HISTORIC AND DESIGN REVIEW COMMISSION

HDRC CASE NO: 2021-011
ADDRESS: 1910 E HOUSTON ST
LEGAL DESCRIPTION: NCB 1372 BLK 40 LOT 40 (HOUSTON STREET DEVELOPMENT)
ZONING: IDZ, H
CITY COUNCIL DIST.: 2
DISTRICT: Dignowity Hill Historic District
APPLICANT: Felix Ziga/Ziga Architecture Studio PLLC
OWNER: Christopher O'Malley/SA HOUSTON STREET DEVELOPMENT PARTNERS LLC
TYPE OF WORK: Construction of a 2-story residential structure
APPLICATION RECEIVED: December 14, 2020
60-DAY REVIEW: Not applicable due to City Council Emergency Orders
CASE MANAGER: Edward Hall
REQUEST:

The applicant is requesting a Certificate of Appropriateness for approval to construct a 2-story residential structure at 1910 E Houston. The new construction on this lot was originally approved by the Historic and Design Review Commission on June 6, 2018, with three other structures, one of which has been constructed. Since that time, the issued HDRC Certificate of Appropriateness has expired. At this time the applicant has noted that approval for only lot 41 is requested.

PROPOSED FLOOR
PLANS & ELEVATIONS

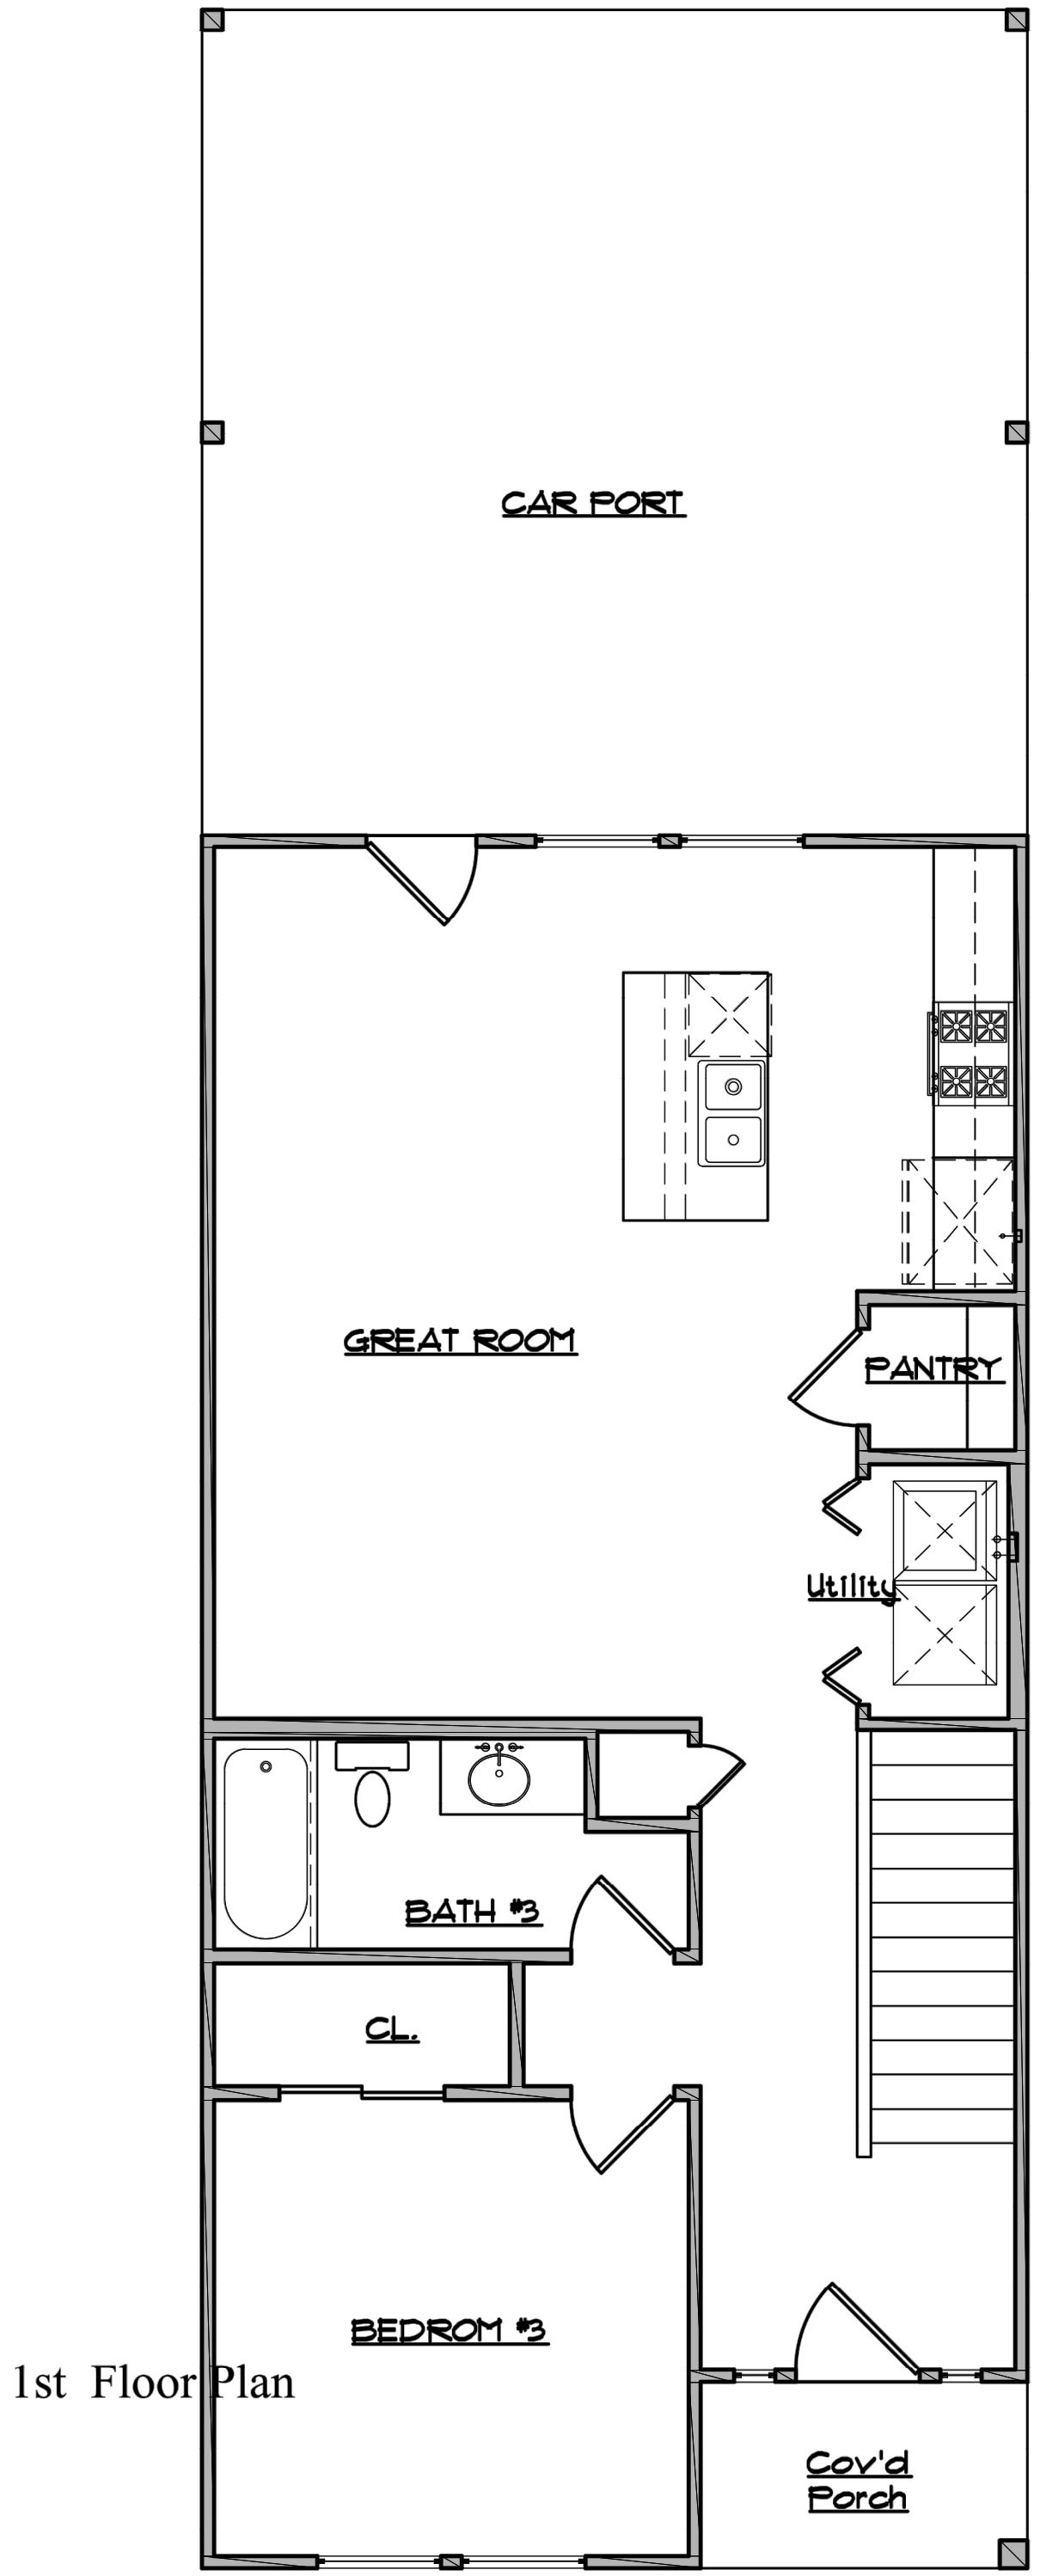
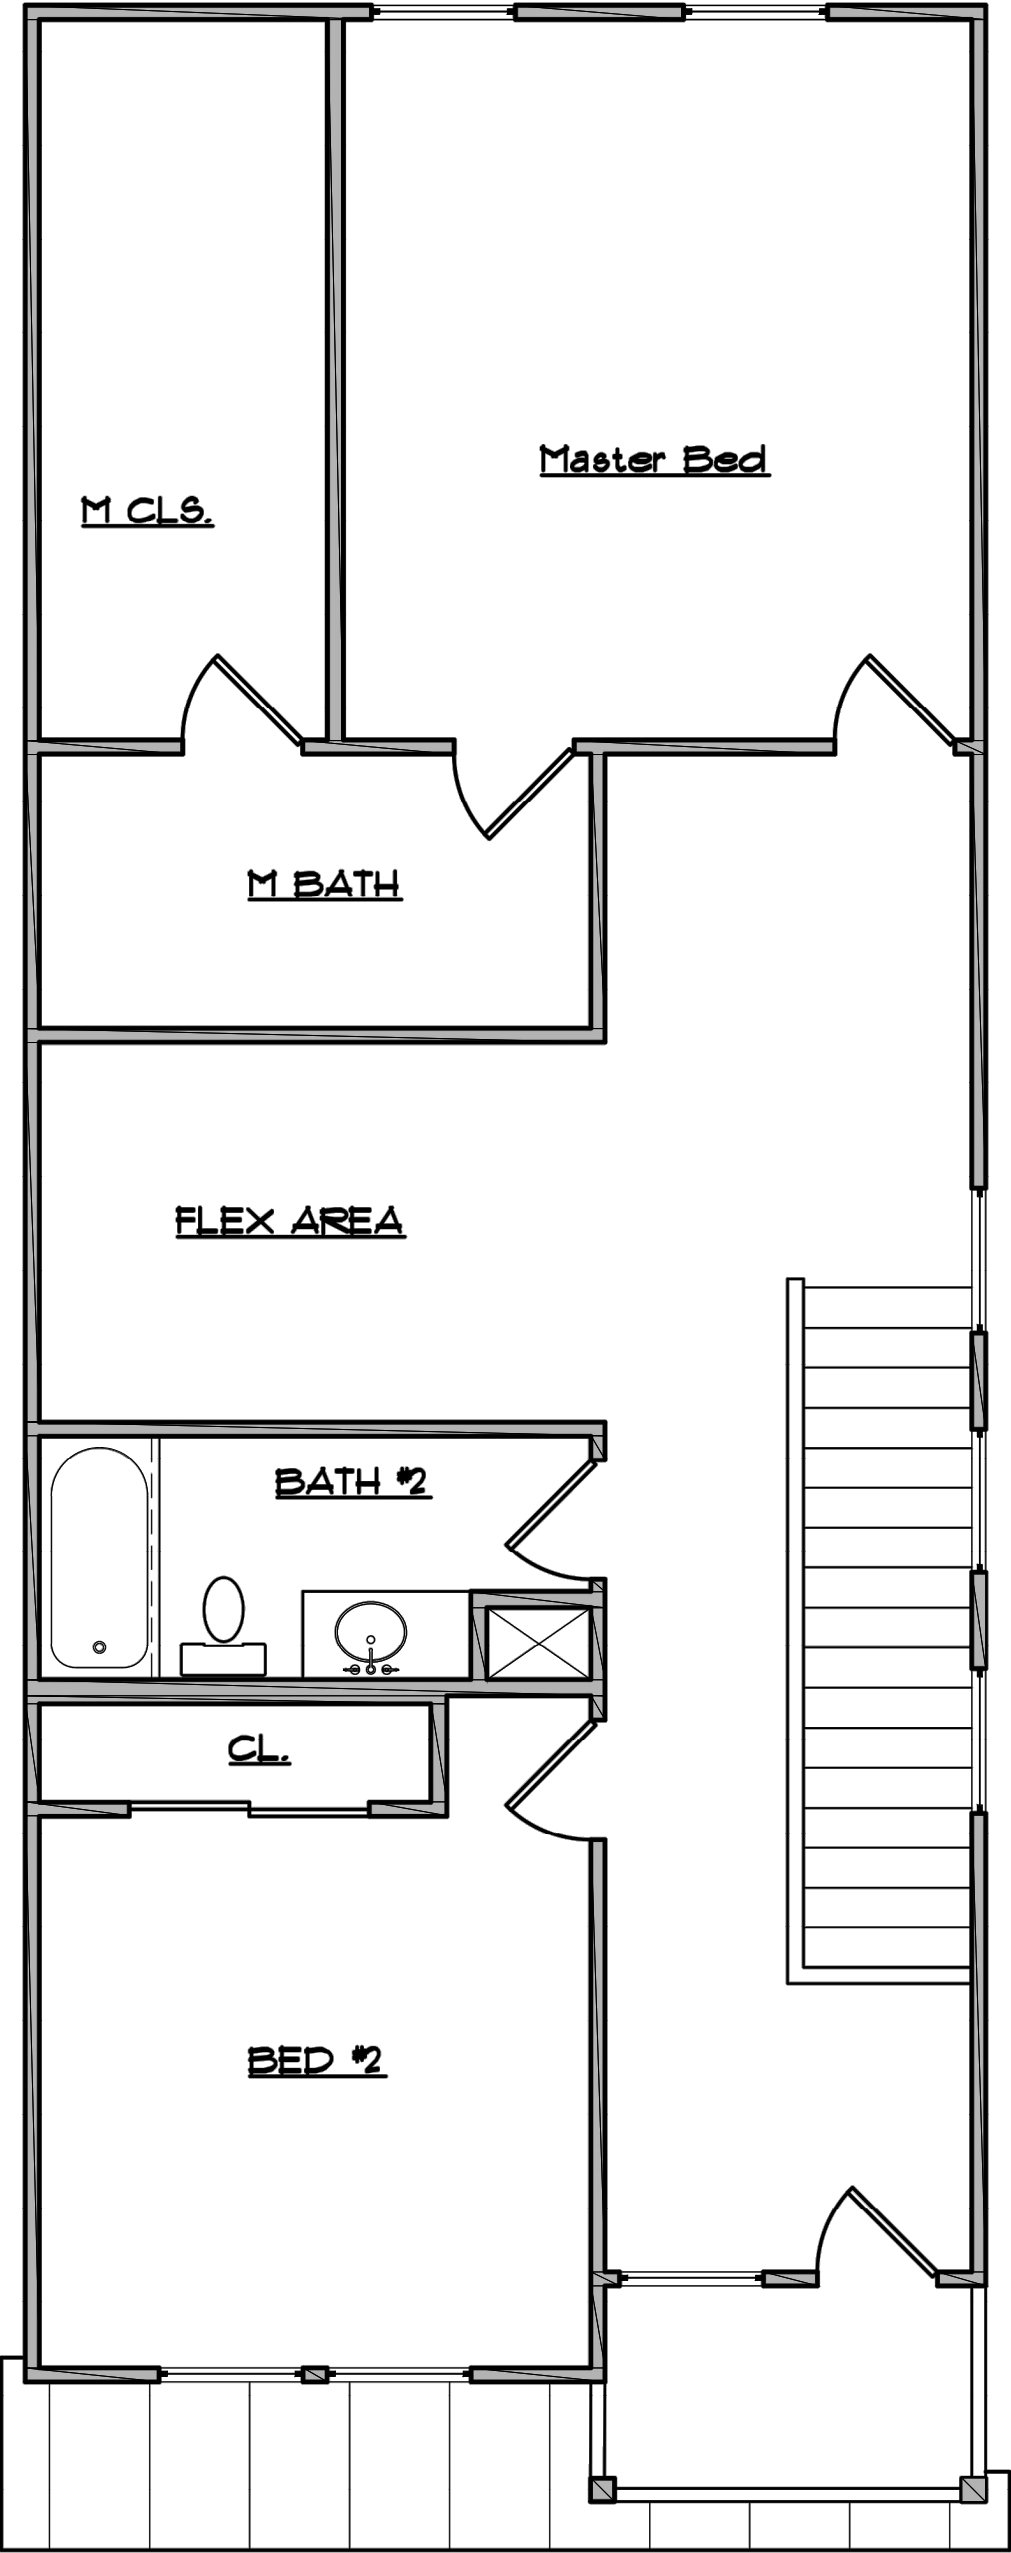
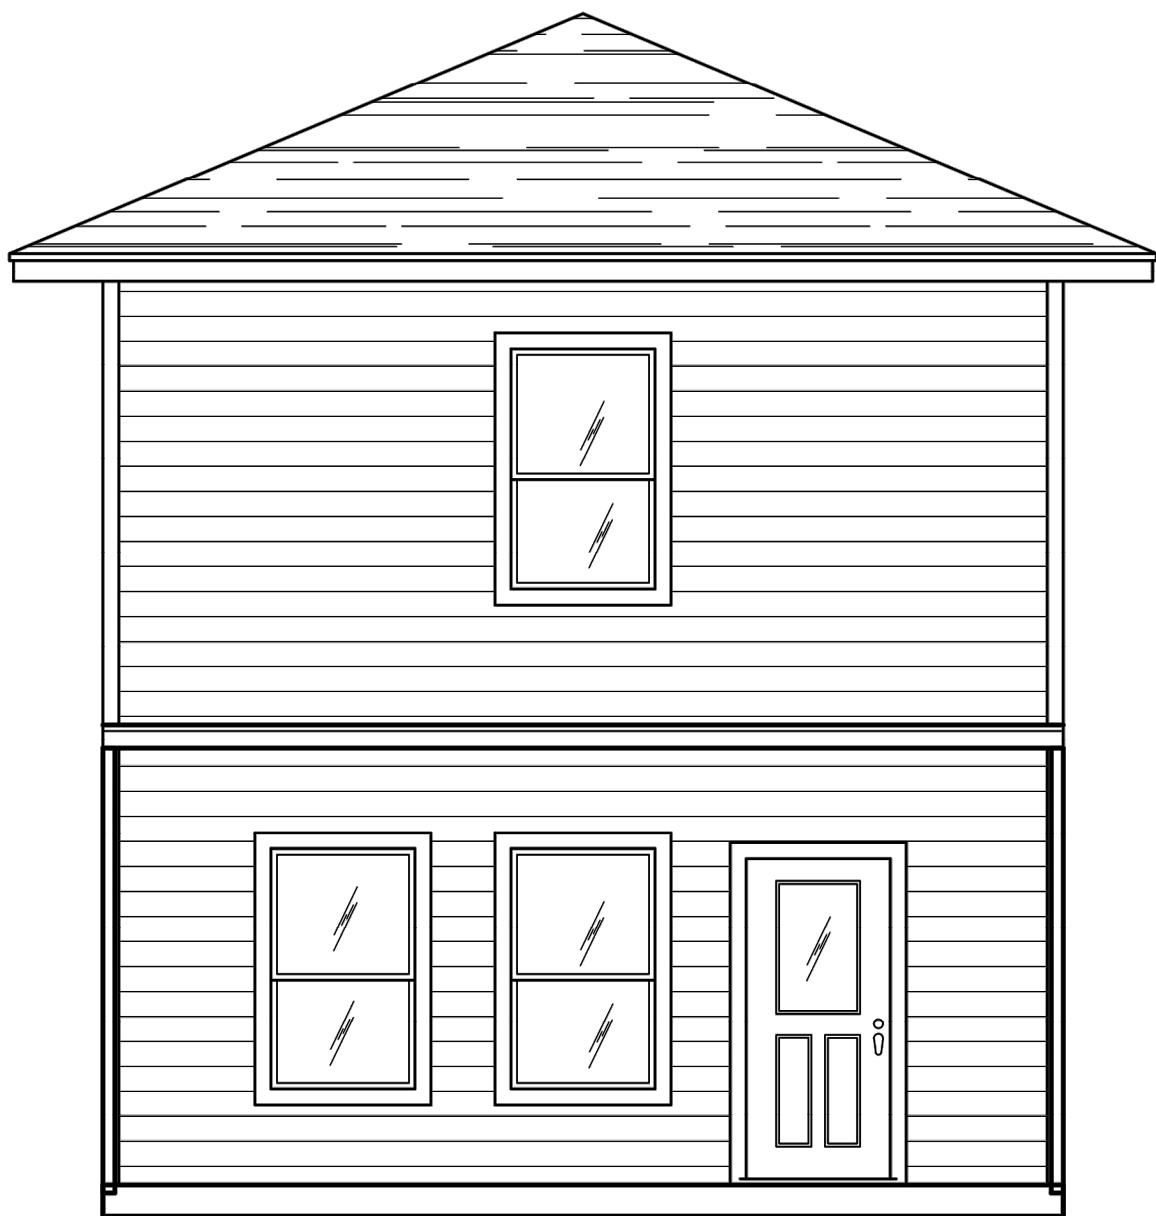
- b. **SETBACKS** – The applicant has proposed a setback for the proposed new construction that is greater than the setback of the historic structure to the immediate south, 426 N Monumental. Generally, staff finds this to be appropriate.

- c. **SCALE & MASS** – Per the Guidelines for New Construction 2.A.i., a height and massing similar to historic structures in the vicinity of the proposed new construction should be used. In residential districts, the height and scale of new construction should not exceed that of the majority of historic buildings by more than one-story. The applicant has proposed for the new construction to feature two stories in height and a footprint of approximately 830 square feet. Staff finds the proposed massing to be appropriate and consistent with the Guidelines.

- d. **ENTRANCES** – According to the Guidelines for New Construction 1.B.i., primary building entrances should be oriented towards the primary street. The applicant has proposed to orient the new construction toward N Monumental. This is consistent with the Guidelines.

- e. **FOUNDATION & FLOOR HEIGHTS** – Per the Guidelines for New Construction 2.A.iii., applicants should align foundation and floor-to-floor heights within one foot of floor-to-floor heights on adjacent historic structures. The applicant has proposed a foundation height that appears to be approximately one (1) foot in height. Staff finds that the applicant should confirm the proposed foundation height.

- f. **ROOF FORMS** – The applicant has proposed for the new construction to feature a front facing gabled roof with a rear hip, a gabled porch/balcony roof and a shed roof above the first level. Generally, the proposed roof forms are consistent with the Guidelines; however, their profiles are inconsistent with the Guidelines and historic examples found historically within the district. Gable returns should be eliminated from each roof. Additionally, the porch roofs should be modified (both the shed and gabled forms) to be consistent with double height roof forms found historically within the district.

- g. **WINDOW & DOOR OPENINGS** – Per the Guidelines for New Construction 2.C.i., window and door openings with similar proportions of wall to window space as typical with nearby historic facades should be incorporated into new construction. The applicant has proposed a number of windows that feature contemporary profiles and sizes. Additionally, the applicant has proposed fenestration patterns on side facades that result in unbroken wall planes. Staff finds that the applicant should install one over one wood or aluminum clad wood windows with equal sash dimensions that are comparable in size to those found historically within the district, and that additional, fenestration should be added to both the north and south facades.

- h. **PORCH MASSING** – Historically within historic districts, double height porches feature architectural and massing elements that are cohesive in design. Historically, double height porches share the same porch element, feature organized column arrangement and read as one form. As proposed, the applicant has designed a recessed ground level porch and a shed roof and a second story roofed balcony. Staff finds that the proposed porch and balcony should be redesigned to read as one element.

- i. **LOT COVERAGE** – Per the Guidelines, the building footprint for new construction should be no more than fifty (50) percent of the size of the total lot area. The applicant has proposed new construction that features a building to lot ratio that is higher than that recommended by the Guidelines; however, this pattern is found historically in the immediate vicinity, specifically on N Monumental. Staff finds the proposed lot coverage to be appropriate.

- j. **MATERIALS** – The applicant has proposed materials that include composite siding with six (6) inch exposures, board and batten siding with battens sixteen (16) inches on center, standing seam metal roofs, staggered shake siding, wood balcony railings, and composition shingle roofing. Staff finds that the proposed composite siding should feature smooth finishes, a thickness of $\frac{3}{4}$ of an inch, mitered corners, and an exposure of four inches. Board and batten siding should feature a smooth finish and boards that are 12 inches in width and battens that are approximately 1.5 inches in width. The proposed standing seam metal roof should feature panels that are 18 to 21 inches wide, seams that are 1 to 2 inches in height and a standard galvalume finish. A crimped ridge seam is to be used and if a ridge cap is requested, it must be approved by staff prior to installation. The proposed railing is to feature a 2x4 top rail, 1x2 trim beneath the top rail, 1 $\frac{1}{2}$ " x 1 $\frac{1}{2}$ " square pickets, and a notched 2x4 bottom rail. The bottom rail should be approximately 3.5 inches above the porch decking.

- l. **ARCHITECTURAL DETAILS** – As noted in the findings above, staff finds that the proposed first and second level porch massing as well as porch roof massing should be modified to be consistent with historic examples found in the district. Additionally, staff finds that fenestration should be added to both the north and south facades.

- n. **WALKWAY** – Houses found historically in the district feature walkways that lead from the front porch to the right of way, regardless of a sidewalk at the right of way exists. Staff finds that the applicant should incorporate a concrete walkway leading from the front porch to the right of way at the sidewalk.

- i. That the applicant provide additional information noting a foundation height that is consistent with the Guidelines, as noted in finding e.
- ii. That the applicant incorporate roof forms, specifically porch roof forms and massing that is consistent with the Guidelines as noted in finding f. Additionally, staff recommends that the gable returns be eliminated.

- iii. That the applicant add fenestration to the north and south facades and that all windows feature traditional profiles and equal sash sizes, as noted in finding g.

- iv. That the applicant incorporate traditional double height porch massing as noted in finding h.
- v. That the proposed composite siding feature smooth finishes, a thickness of $\frac{3}{4}$ of an inch, mitered corners, and an exposure of four inches. Board and batten siding is to feature a smooth finish and boards that are 12 inches in width and battens that are approximately 1.5 inches in width. The proposed standing seam metal roof is to feature panels that are 18 to 21 inches wide, seams that are 1 to 2 inches in height and a standard galvalume finish. A crimped ridge seam is to be used and if a ridge cap is requested, it must be approved by staff prior to installation. The proposed railing is to feature a 2x4 top rail, 1x2 trim beneath the top rail, 1 $\frac{1}{2}$ " x 1 $\frac{1}{2}$ " square pickets, and a notched 2x4 bottom rail. The bottom rail is to be approximately 3.5 inches above the porch decking.

- vi. That wood or aluminum clad wood windows that are consistent with staff's standards specifications for new construction are used, as noted in finding k. Additionally, staff recommends that the proposed windows feature equal sashes, traditional dimensions, and that all grouped windows are separated by mullions of six (6) inches in width. All window openings should feature traditional trim and sill details, as noted in the applicable citations.

- vii. That a front, concrete walkway be installed and that a detailed landscaping plan be submitted for review and approval, as noted in findings n and o.
